# SERVICE BULLETIN

M-893

## STARTER ACTUATOR IMPROVEMENTS FLH-FX BELT DRIVE MODELS

Figure 1. Starter Actuator Assembly

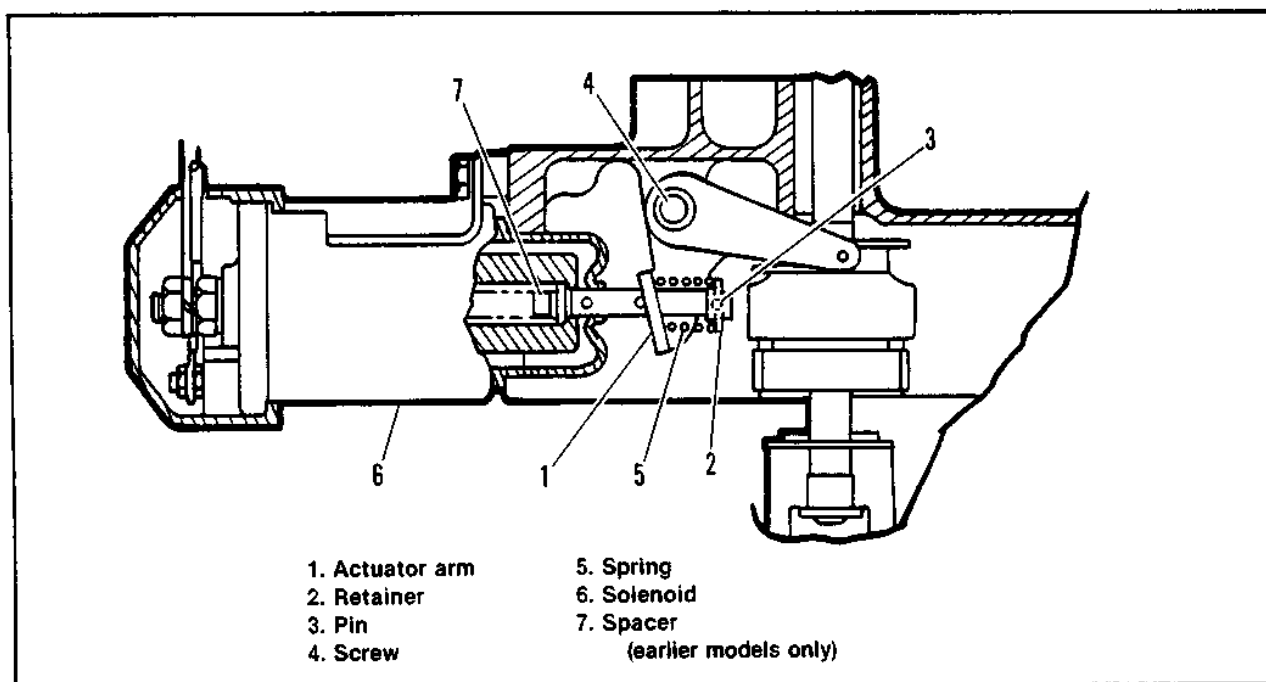
Starting in late 1984, secondary belt drive FLH and FX production vehicles were equipped with improved starter drive actuator components. See Figure 1. The new parts consist of actuator arm (1), Part No. 31300-84, spring retainer (2), Part No. 31439-84 and pin (3), Part No. 257. The new configuration of actuator arm and the new positive seating spring retainer provide a smoother system of starter motor drive engagement and disengagement.

1. See Figure 1. Remove pin (3), retainer (2), spring (5), solenoid (6), screw (4) and actuator arm (1).

**Figure 2. Checking Spring Length**

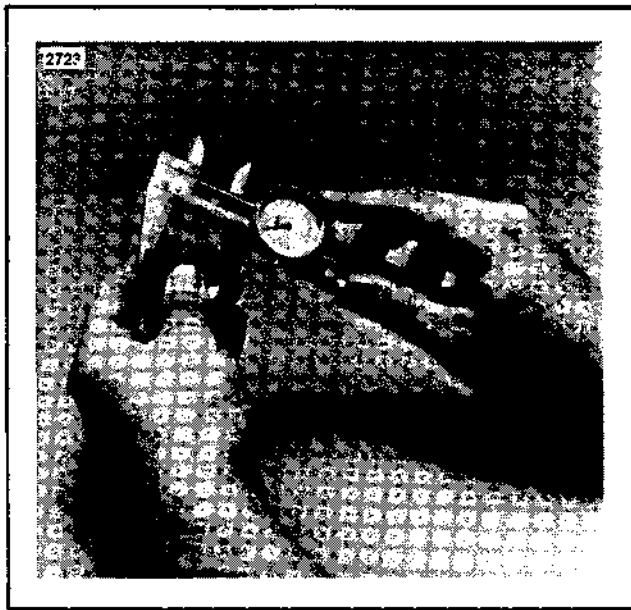
2. See Figure 2. With dial caliper check free length of spring. Spring (5), Figure 1 must be within 1.09 in. to 1.15 in. long. If the spring is not within this tolerance, it must be replaced with a new spring, Part No. 31438-65A.
3. See Figure 1. Remove solenoid cover from solenoid (6). Check if there is a spacer (7) between the inner plunger and the plunger shaft. The spacer should be discarded.
4. Reassemble using new actuator arm (1), Part No. 31300-84, new spring retainer, Part No. 31439-84 and new pin, Part No. 257.

**Figure 3. Spring Retainer Assembly**

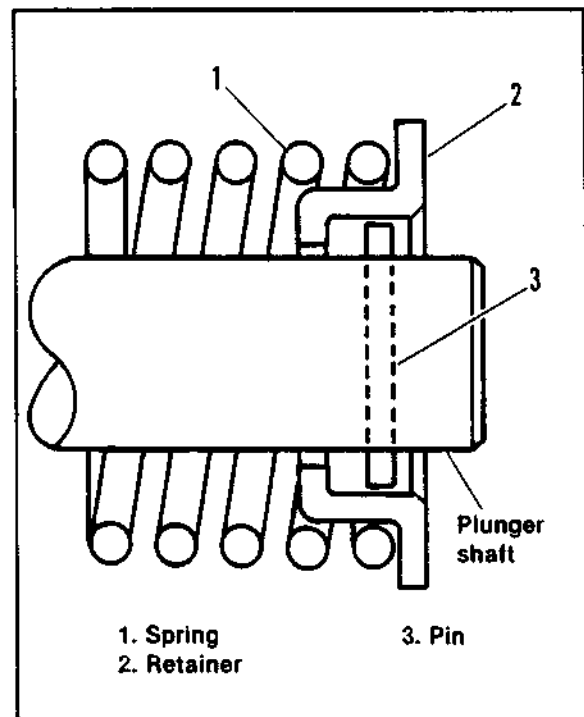
Assemble retaining cup (2) and pin (3) as shown in Figure 3.
